CASE # H-15-073A ADDRESS: 800 Gildersleeve Street
Historic Status: Contributing
Historic District: Don Gaspar Area

Re: Primary Elevation Designation (Main Residence) and Historic Status (Casita) at 800 Gildersleeve

5. **Case #H-15-073A. 800 Gildersleeve Street.** Don Gaspar Area Historic District. Andrew Lyons, agent for Roxanne and Brian Morgan, owners, requests primary façade determination for a contributing primary residential structure and historic status review of a non-stateded accessory structure. (David Rasch).

- 3. Case #H-15-073B. 800 Gildersleeve Street. Don Gaspar Area Historic District. Andrew Lyons, agent for Roxanne and Brian Morgan, owners, proposes to construct a 177 sq. ft. carport addition to a height of 10'7" on a primary façade, a yardwall with pedestrian gates and vehicle gates, and change windows on a contributing residential structure, and to**

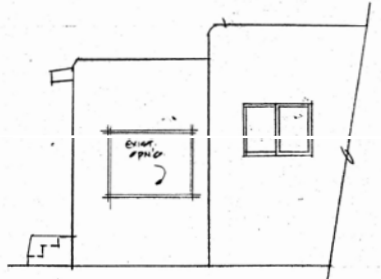
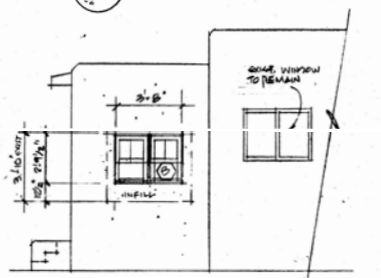
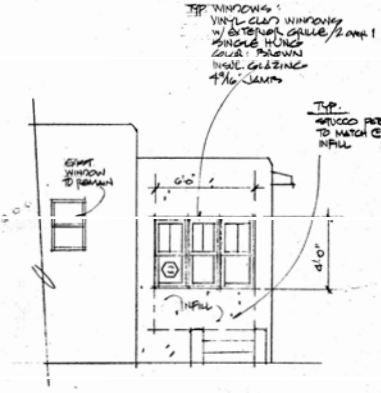
- PLANNING & LAND USE -	
<input checked="" type="checkbox"/> HISTORIC DESIGN REVIEW	REMARKS: MATCH HISTORIC SPACING AND COLOR FOR OTHER SASHES
<input checked="" type="checkbox"/> LANDSCAPE REVIEW	
<input checked="" type="checkbox"/> ENVIRONMENTAL ACTION REVIEW	
<input checked="" type="checkbox"/> PERMITS	
<input checked="" type="checkbox"/> DEPARTMENT APPROVAL	
<input checked="" type="checkbox"/> BLOCK	
DATE: 10.20.04	26
NAME: A. CHRISTOPHER KUNZ

Ms. Farrar said the Board needed to figure out on the primary elevation how to retain the character of the portal.

Ms. Farrar said it would be better to keep the front porch feel of the home. She noted that in this district there was no 30" rule.

Mr. Bell said keeping the opening large would be best. He suggested that French doors would be a better option. He said divided light windows without changing sizes would also be better.

Mr. Rios said she would go with the vinyl, saying it should not be made to look like a room. Mr. Bell said "Vinyl??"

Ms. Rios said the sliding door side should match the other side. Mr. Bell said he was not in favor of aluminum or viny.

Ms. Farrar moved for approval of Case #H 04-154 to maintain the 1970's openings on the porch using the windows which the applicant now owns. Ms. Rios seconded the motion and it passed by majority voice vote with all voting in favor except Mr. Bell who voted against.

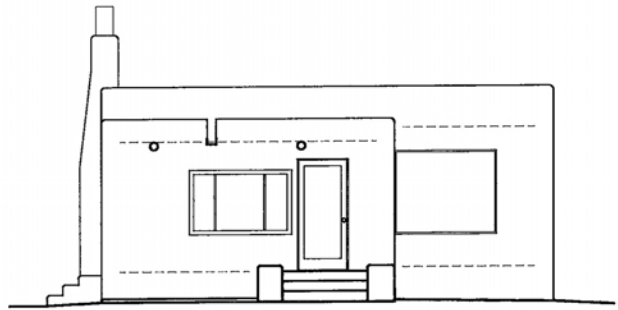
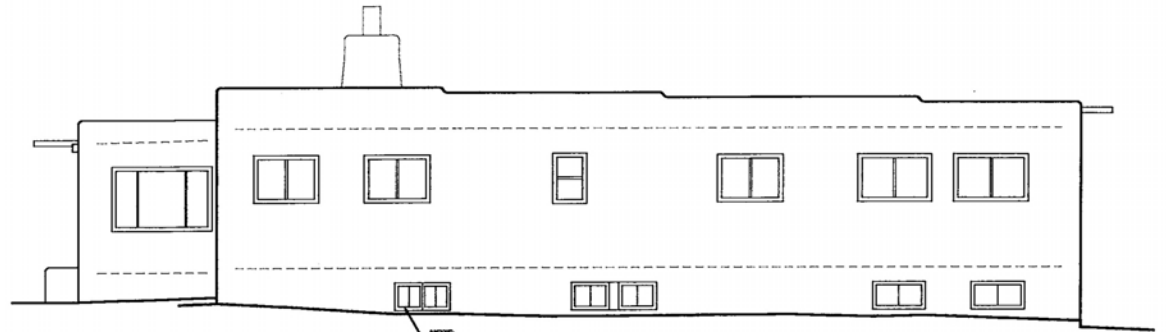
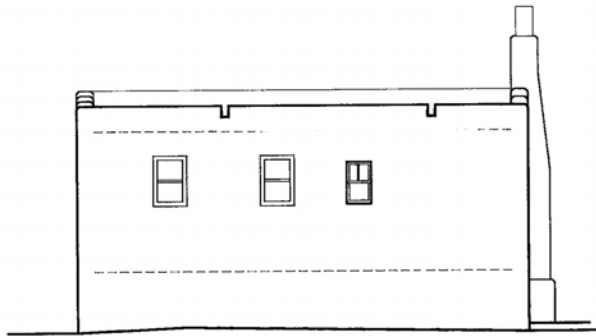
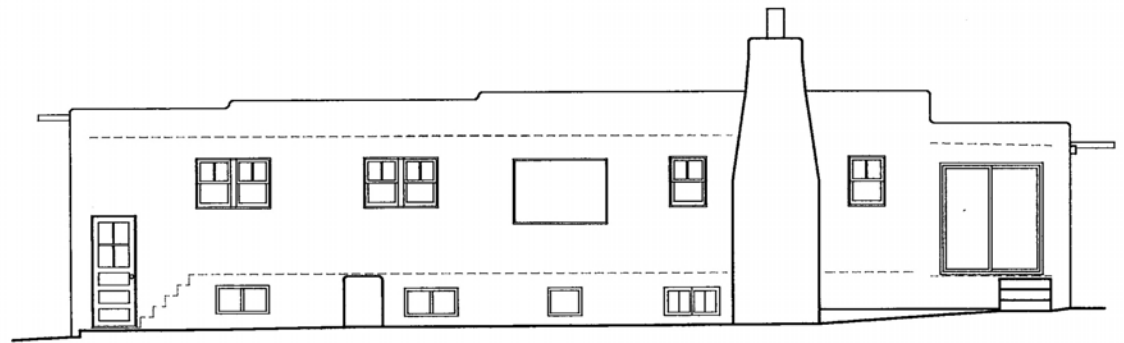
Member Boniface noted the south part of the portal was infilled with a non-historic sliding patio door. It also appeared there was something similar to that going on the north side of that same portal. He asked if Staff was suggesting the north side of that portal would not be primary.

Mr. Rasch said that was a good question. He did not suggested the north elevation of the portal should be primary. It does have that massing interest but he didn't see anything on the north being different from the east or the west. And on any of the portal, if the Board does make the east, north or south parts of the

Member Boniface said it would include the existing opening size and width, so the applicant would need to honor the opening size. He asked if Mr. Lyons understood that.

Member Boniface said the opening that the patio door is in, would have to remain (at its present dimensions). It could not change in size but the applicant could infill the opening with something more historically in keeping with the rest of the house. But it would have to come back to the Board for approval. If a motion was made to have that south side designated as primary and later they decided they wanted to upgrade those patio doors, they could not infill that opening.

Staff recommends that the Board maintain the contributing historic status of the residence and designate the east and south facades (elevations 1, 2, 3, and 6) as primary and to assign contributing historic status to the converted garage with the east elevation (1) designated as primary.

Member Boniface moved in Case #H-15-073A at 800 Gildersleeve Street, to retain contributing status and approved per staff's recommendation, to designate the east and south façades, elevations 1, 2, 3 and 6 as primary and to assign contributing historic status to the converted garage with the east elevation, #1, designated as primary and indicating that the Applicant has recognized non-historic windows and doors in some openings he might later request to upgrade. Member Roybal seconded the motion.

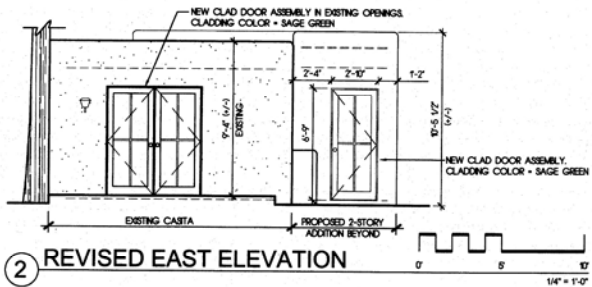
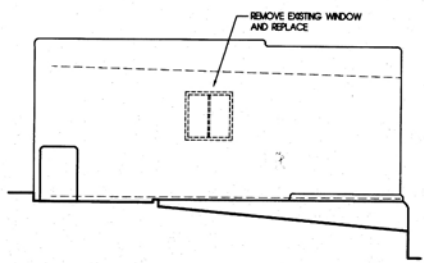
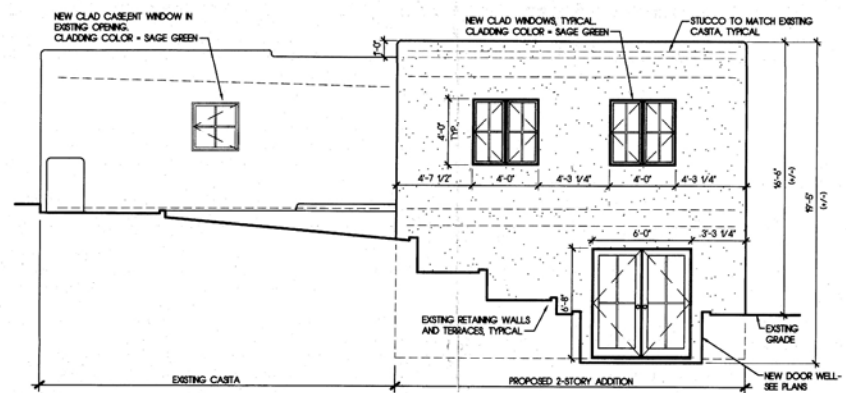
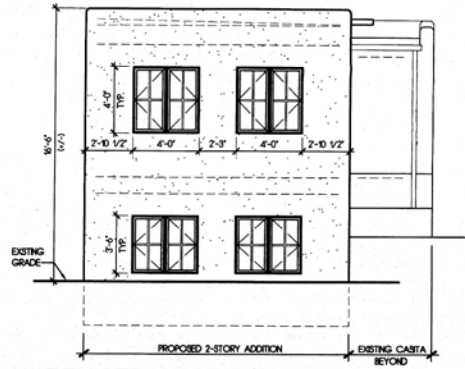
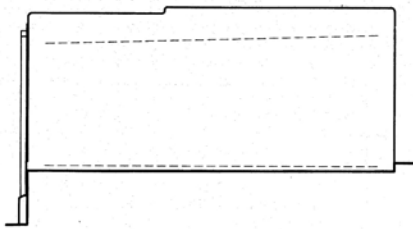
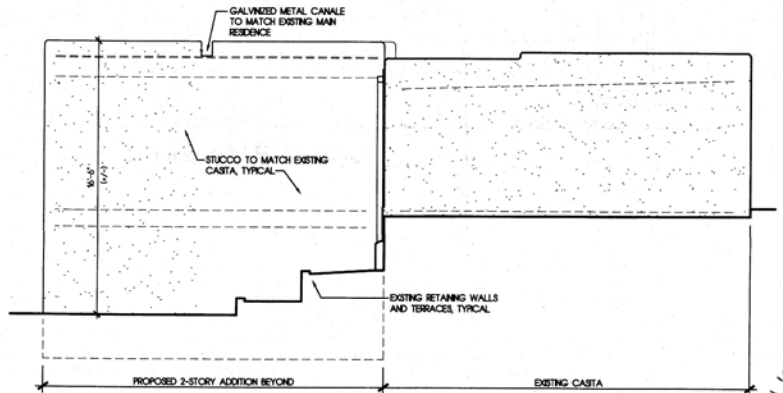
Member Boniface said in reviewing the elevation drawings of the Casita, it appears that the lower floor is probably buried about three feet at least on three sides and even steps up on the north and south sides as well. So the only spot where there is actually 19'+ wall is just right where the French doors at the entry on the ground floor on the north elevation and the entire west elevation. It looks like all three sides – the fourth side being contained by the existing casita/garage. He understood the Board still needs to make an exception for that but wanted to clarify that it is the case.

Member Katz said a door is being added on the bottom floor of the main house and it goes into a dining room. It also is not centered under the window above it. He wondered if it wouldn't be more aesthetically pleasing to have it centered under the window and also more functional as one wouldn't walk into the door and face the table in the middle of the room but walk into the door to the wide of the table.

Member Boniface said with regard to what Member Katz just brought up, that he actually liked the fact that they didn't line up so you can actually tell the difference between what is a contributing building and then what was added later. So he actually wanted to see the difference.

Member Boniface moved in Case #H-15-073B at 800 Gildersleeve Street, to accept Staff's recommendation and approve this application as presented and recognizing that the applicant has met all of the exception criteria for 1) an addition on a primary façade, south, 2) an addition less than ten feet back from a primary façade, east, 3) to create an opening on a primary façade, south, for a window, 4) an increase to maximum allowable height, and 5), an increase to exceed the 50% footprint standard. In addition, he added the following conditions: 1) that the stair be taken to staff for their approval; 2) the existing stairs on the south elevation which go into the entry portal be extended in width to match the same opening as the doors leading into the portal. Member Bayer seconded the motion.

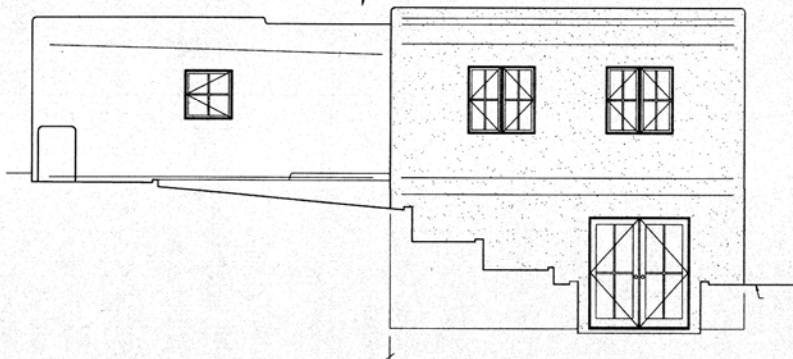
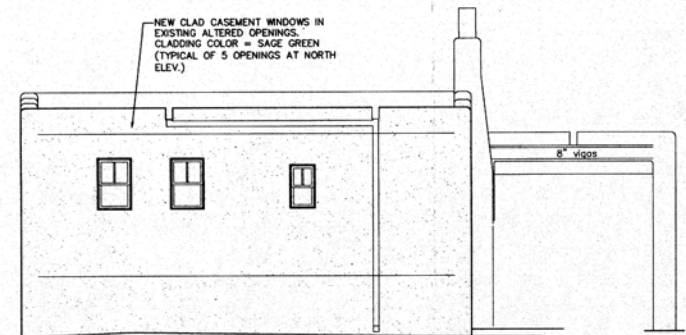
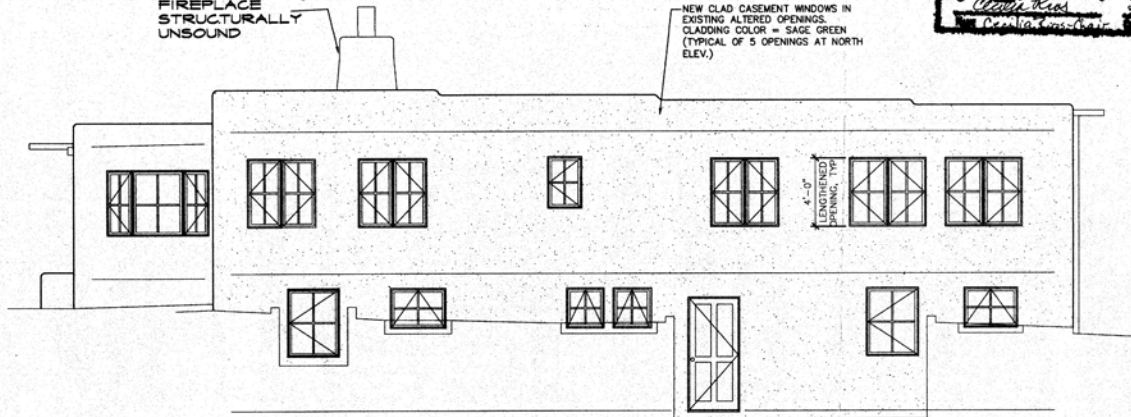
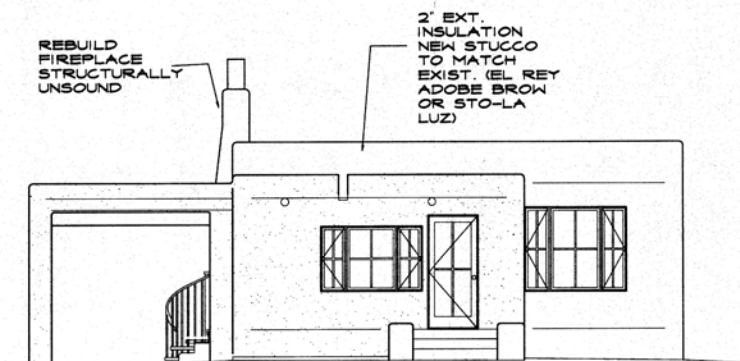
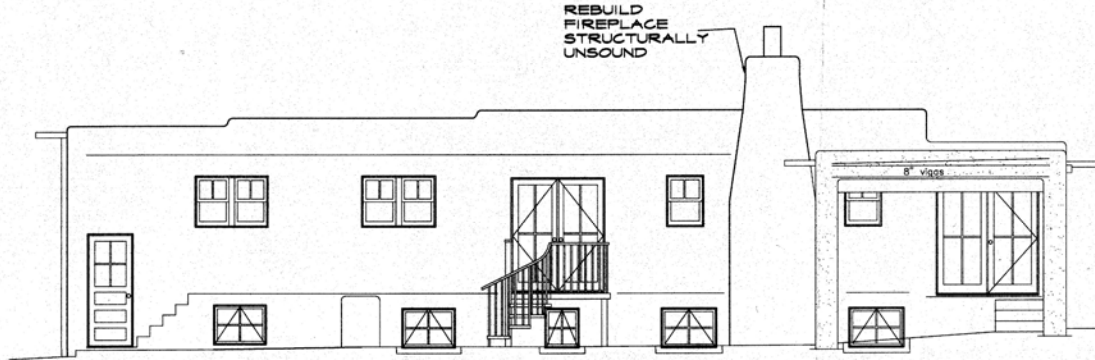
Member Boniface said these drawings are impossible to understand. The drawings are mis-labeled in terms of elevations and the elevations don't match the floor plans. The Board needs to postpone this and ask the applicant to submit accurate drawings.
